To: T10 Technical Committee
 From: Jay Neer (Jay.Neer@Molex.com)
 Date: March 17, 2005
 Subject: SAS 1-1 Compact Connectors (Internal and External)

This proposal has been prepared in the style of SAS 1-1 Rev 8, and identifies changes and additions to Rev 8. This revision incorporates the changes requested by the SAS Phy working group.

Figure 61C — SAS external compact cable plug connector

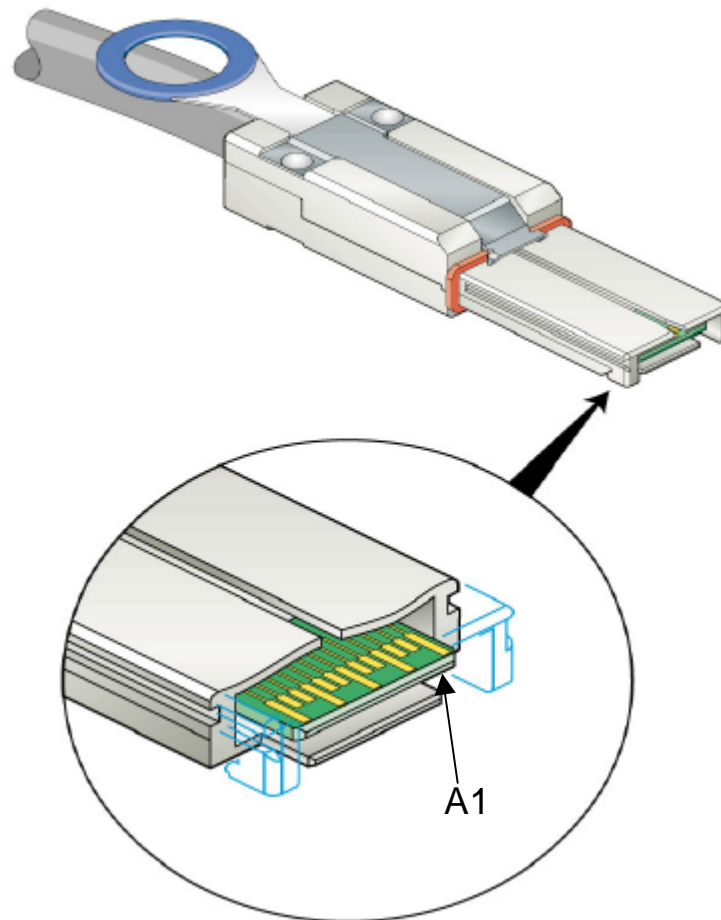
5.2.3.3.4 SAS external compact cable plug connector

The SAS external compact cable plug connector with latch is defined in SFF-8088 as the free (plug) cable connector. SFF-8086 defines the circuit board (the circuit board is common to both internal and external connectors).

The SAS external compact cable plug connector shall not include keys and may include key slots. Key slots are not defined by this standard. The SAS external compact cable plug connector attaches to a SAS external compact receptacle connector, providing contact for up to four physical links.

Figure 62C — SAS external compact receptacle connector

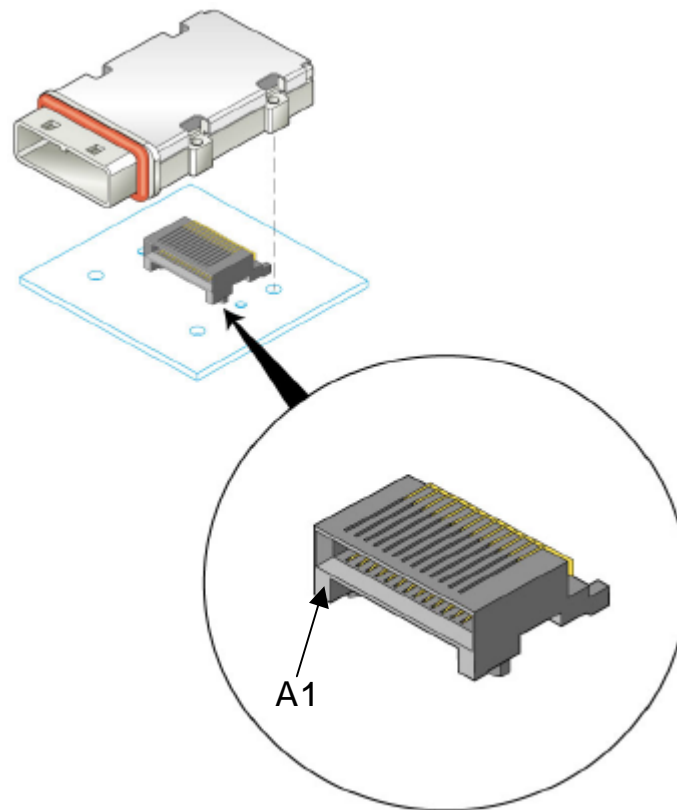
5.2.3.3.5 SAS external compact receptacle connector

SAS devices with external ports shall use the SAS external compact receptacle connector. The SAS external compact connector is defined in SFF-8088 as the fixed (receptacle) right angle connector. SFF-8086 defines the receptacle mating interface (the receptacle body is common to both internal and external connectors).

The SAS external compact receptacle connector shall not include keys and may include key slots. Key slots are not defined by this standard. The SAS external compact receptacle connector attaches to a SAS external compact cable plug connector, providing contacts for up to four physical links.

Figure 63CW — SAS internal compact wide cable plug connector

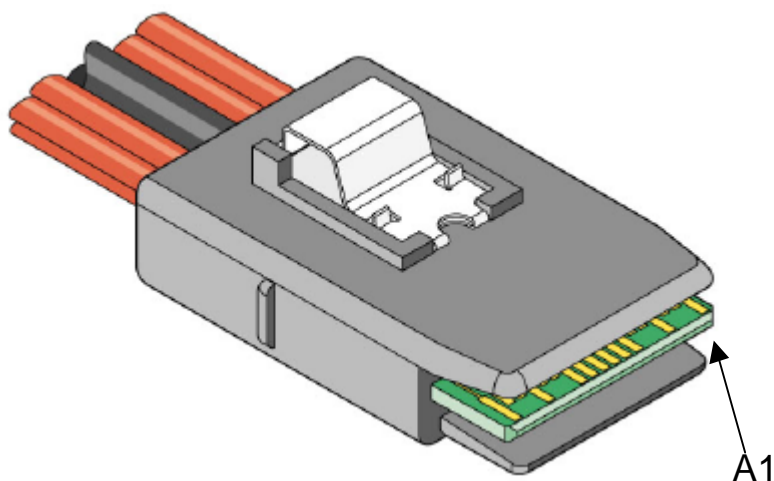
5.2.3.4.4 SAS internal compact wide cable plug connector

The SAS internal compact wide cable plug connector assembly is defined in SFF-8087 as the fixed (receptacle) right angle connector. SFF-8086 defines the circuit board (the circuit board is common to both internal and external connectors).

The SAS internal compact wide cable plug connector attaches to a SAS internal compact wide receptacle connector, providing contact for up to four physical links and eight sideband signals.

Figure 64CW — SAS internal compact wide receptacle connector

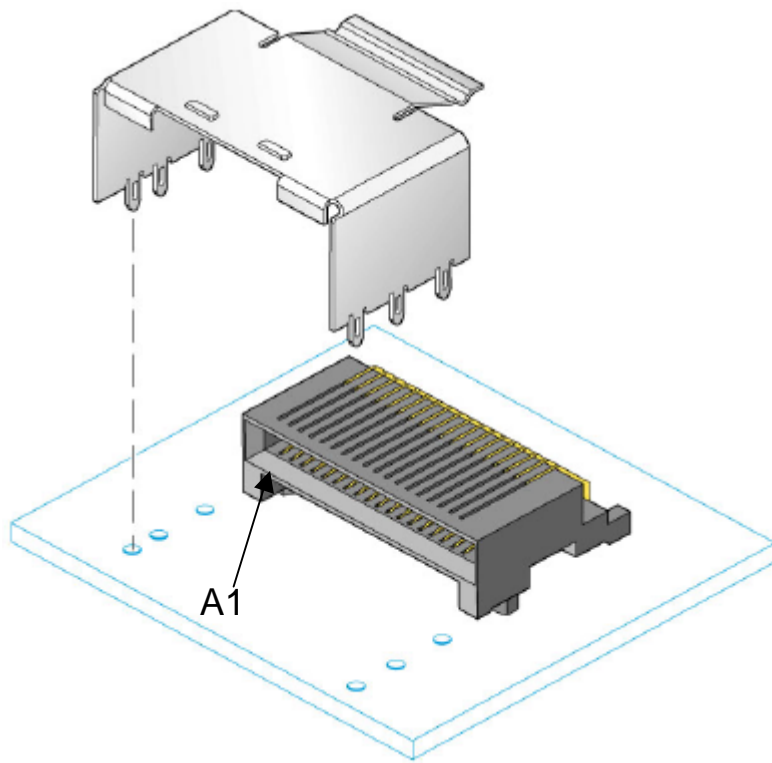
5.2.3.4.5 SAS internal compact wide receptacle connector

The SAS internal compact wide receptacle connector is defined in SFF-8087 as the fixed (receptacle) right angle connector. SFF-8086 defines the receptacle mating interface (the receptacle is common to both internal and external connectors).

The SAS internal compact wide cable plug connector attaches to a SAS internal compact wide receptacle connector, providing contact for up to four physical links and eight sideband signals.

Figure 67CW - SAS internal compact wide cable attaching controller to backplane

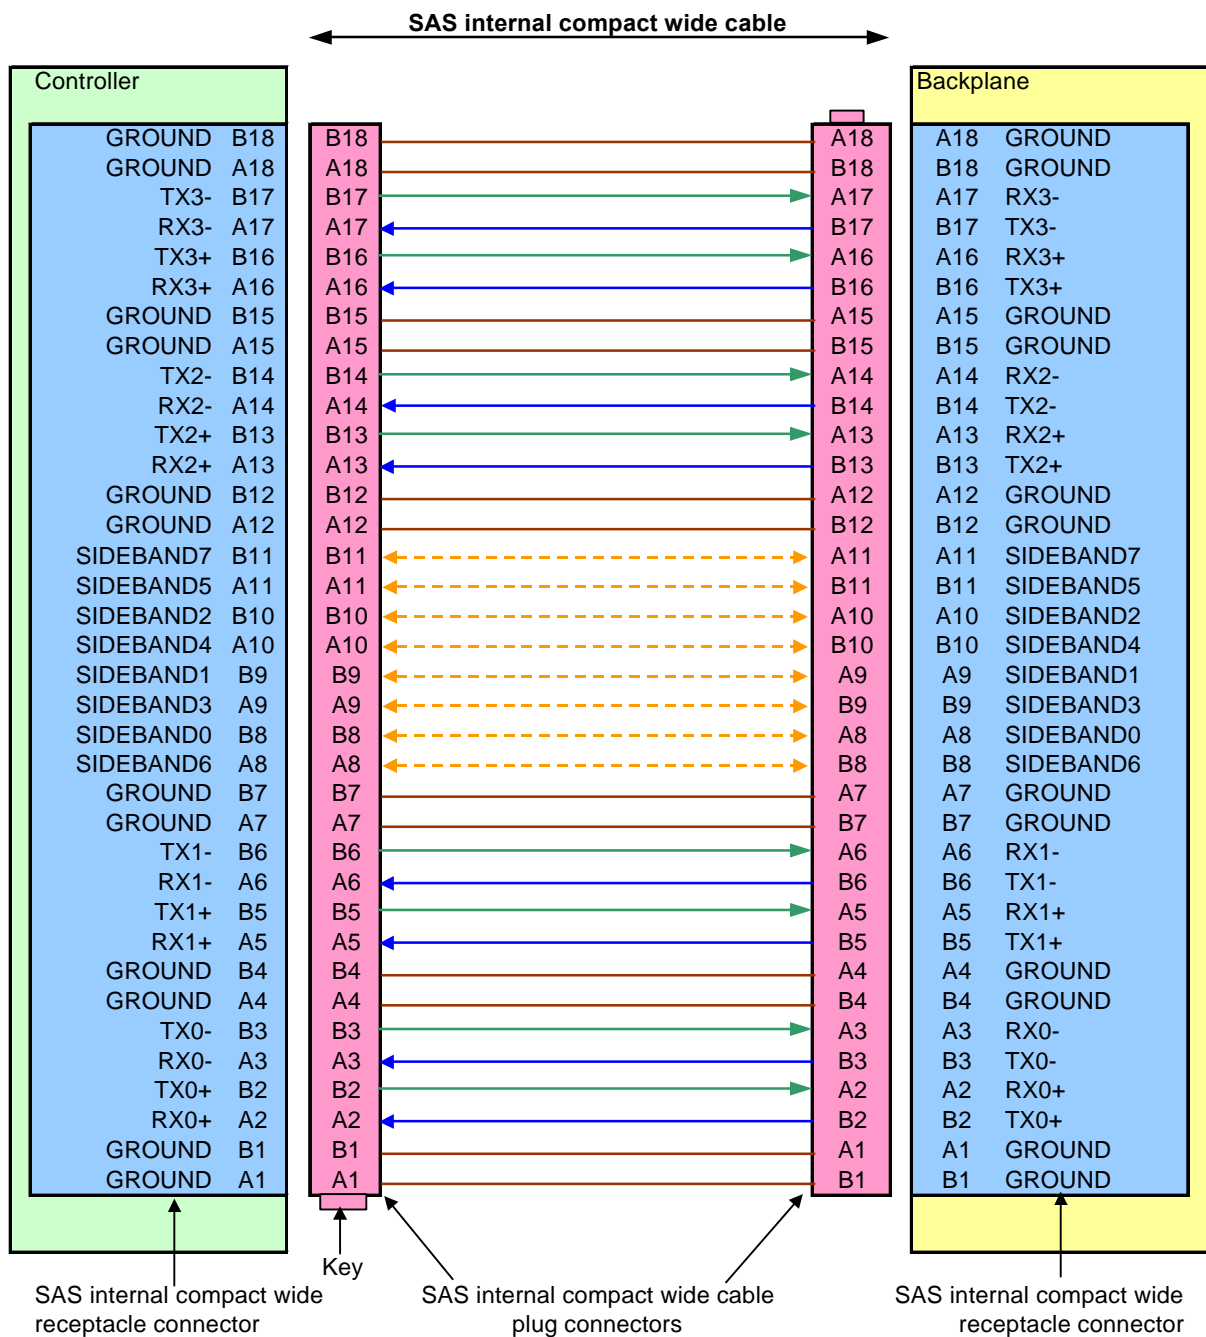
5.2.4.3.2 SAS internal compact wide cable usage

- a) symmetric cable: SAS internal compact wide cable plug connectors on each end;
- b) controller-based fanout cable: SAS internal compact wide cable plug connector on one end (i.e., the controller end) and four SAS internal cable receptacle connectors on the other end (i.e., the backplane end); and
- c) backplane-based fanout cable: Four SATA-style signal cable receptacle connectors on one end (i.e., the controller end) and a SAS internal compact wide cable plug connector on the other end (i.e., the backplane end).

Although the SAS internal compact wide cable plug connector always supports four physical links, the SAS internal wide cable may support one, two, three, or four physical links when used for controller-to-backplane applications.

NOTE 8CW - For controller to backplane uses, up to four physical links may be used. SIDEBAND signals on the controller are attached to the corresponding SIDEBAND signals on the backplane (e.g., SIDEBAND0 of the controller is attached to SIDEBAND0 of the backplane)

Figure 68CW - SAS internal compact wide cable attaching controller to controller

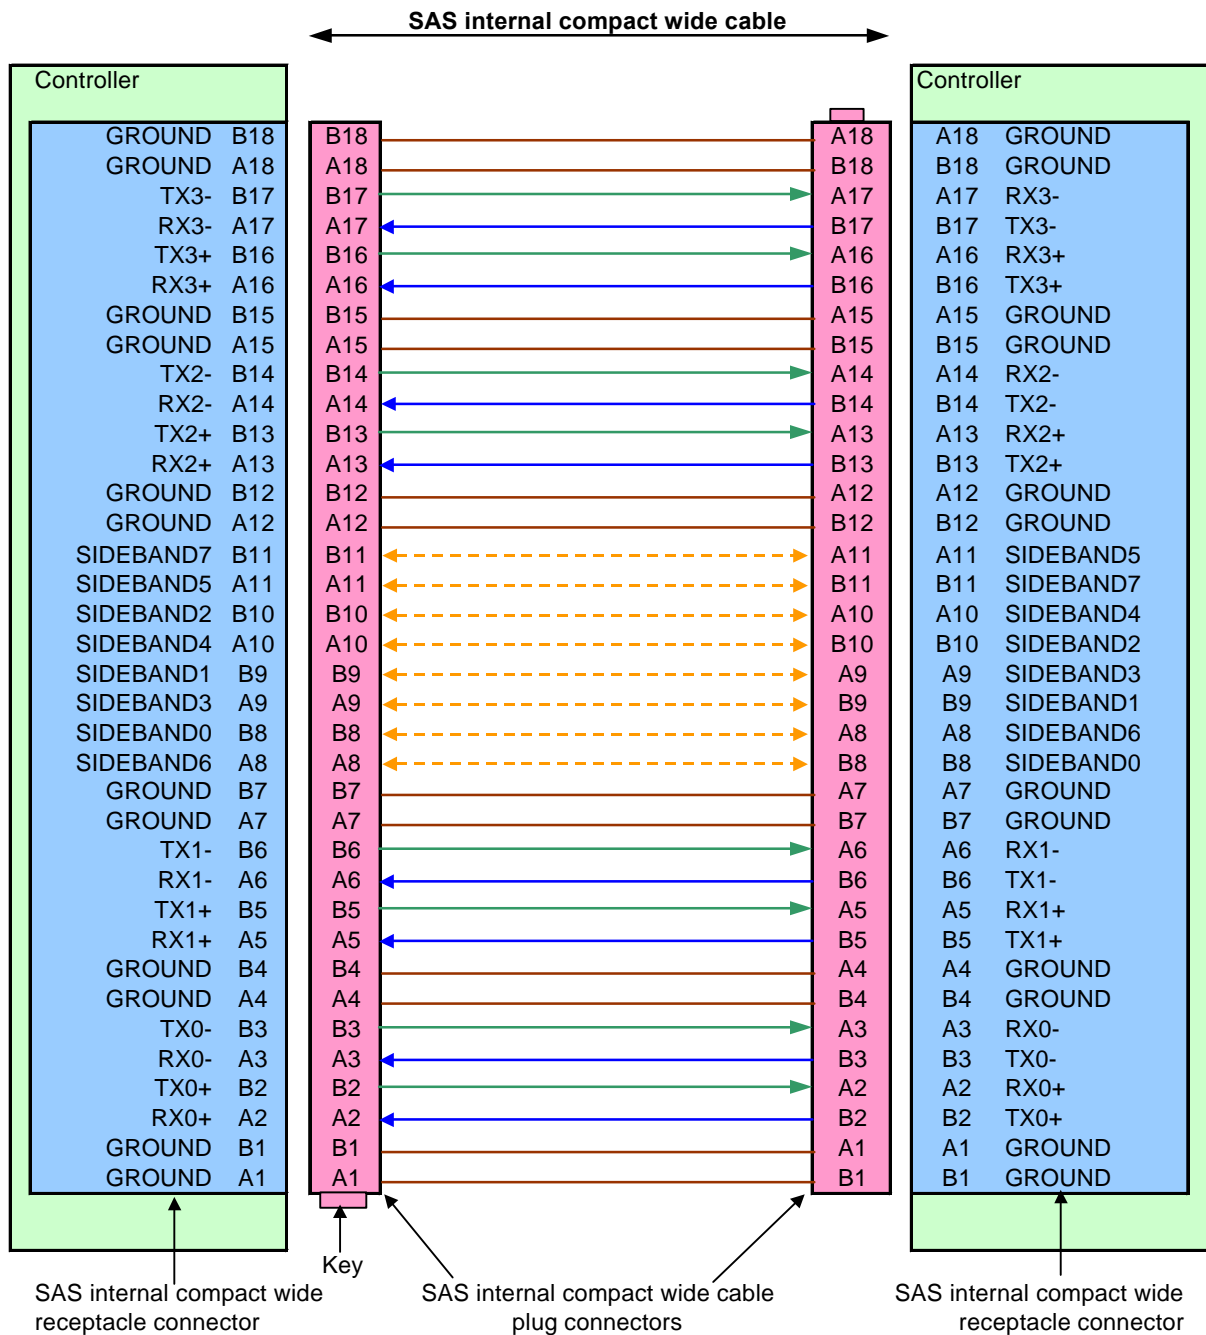
NOTE 10CW - For controller to controller uses, SIDEBAND signals on one controller are not attached to their corresponding SIDEBAND signals on the other controller (e.g, SIDEBAND0 of one controller is attached to SIDEBAND6 of the other controller).

Figure 6969CW - SAS internal compact wide controller-based fanout cable

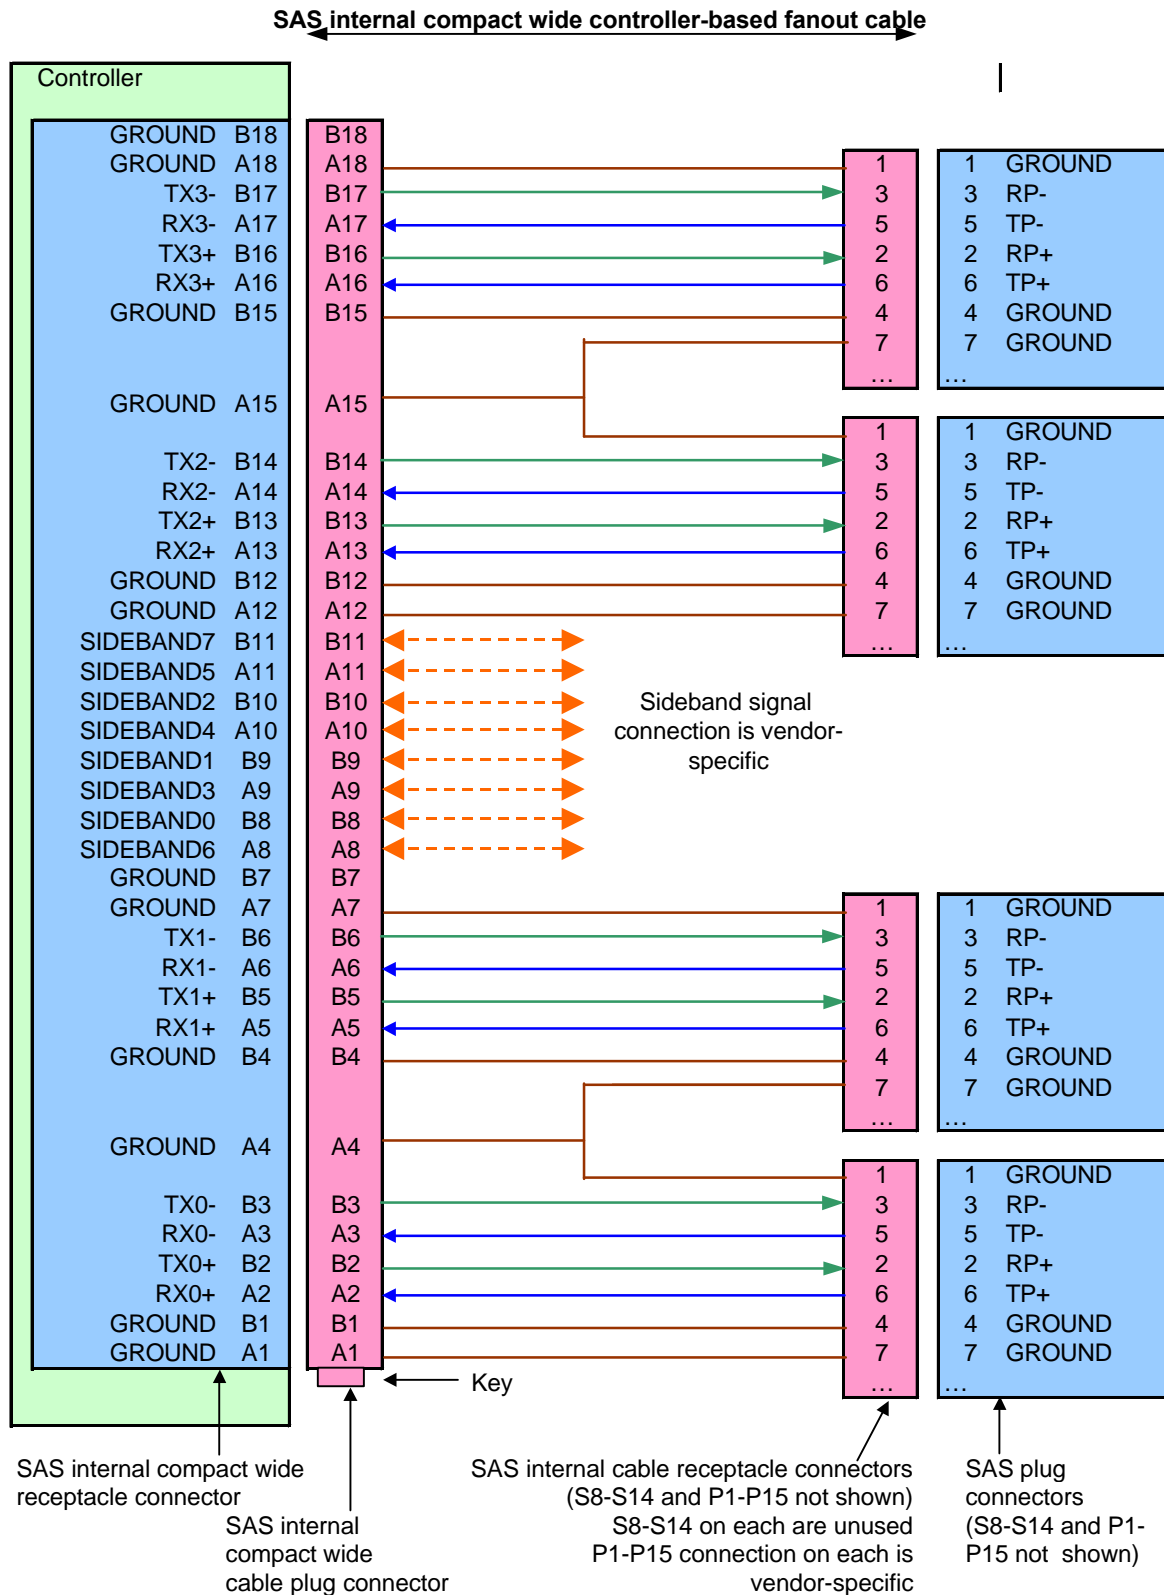
Figure 6969CW shows the SAS internal compact wide controller-based fanout cable.

Figure 70CW - SAS internal compact wide backplane-based fanout cable

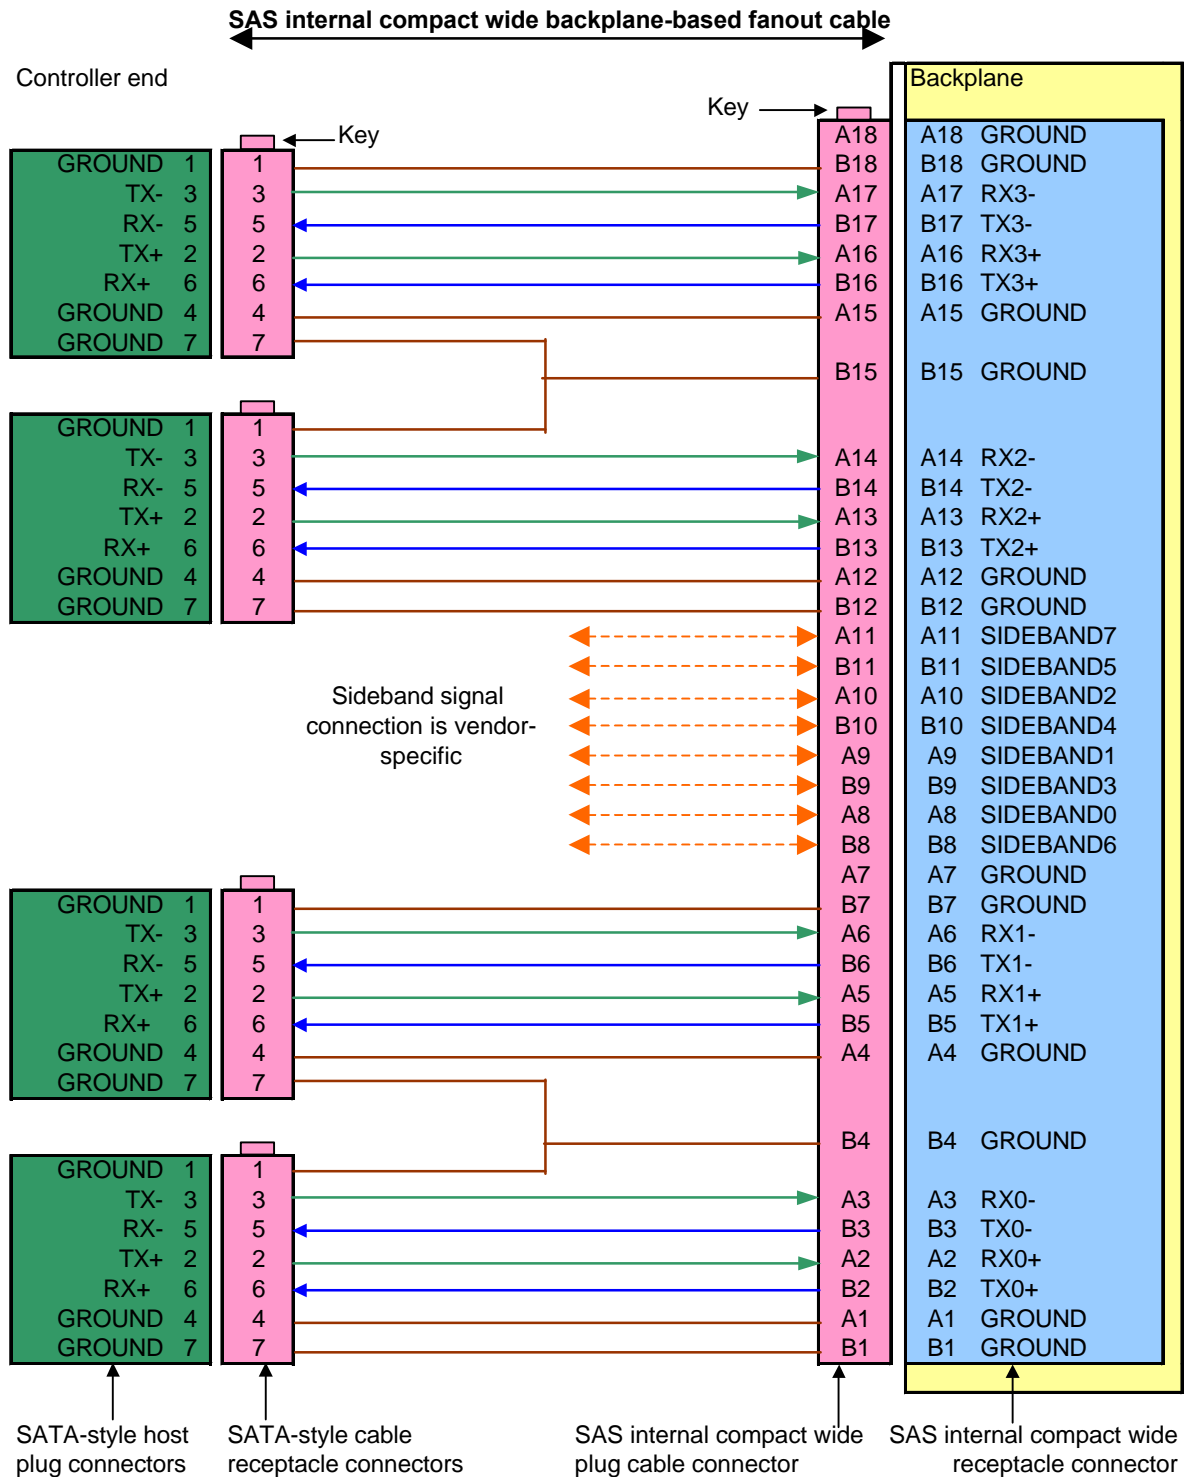
Figure 70CW shows the SAS internal compact wide backplane-based fanout cable.
